Author comments on

“Automated gas bubble imaging at sea floor – a new method of in situ gas flux quantification”

by K. Thomanek et al.

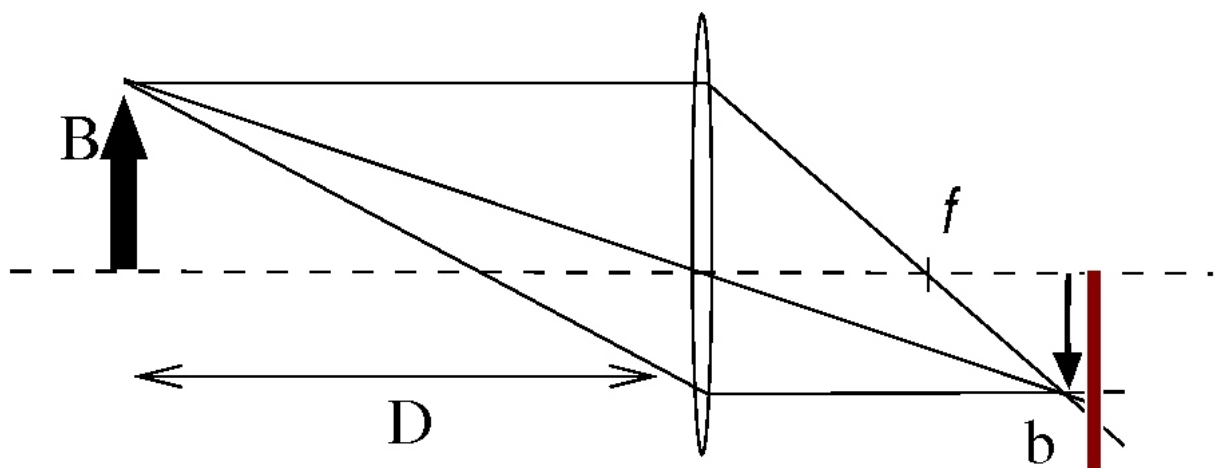
- 2) *Fig 1 is not very informative. I would like see an optical layout for the instrument (even though this might be simple).*

Figure 1 is intended as a simplified sketch showing the system in its components. This way we hope to assist the reader in comprehending the critical parts as the manuscript continues to describe each component. For simplicity the optical layout is drawn below.

In linear optics light is refracted at the lens in such a way that the Bubble-object 'B' is mapped onto the Bubble-image 'b' at the sensor chip of the camera (red bar). The distance between bubble and lens is 'D'. In Figure 1 of the manuscript the bubbles rise in the volume of observation confined between illumination (1) and box (2). 'f' denotes the focal length and has an impact on the size of the observed volume.
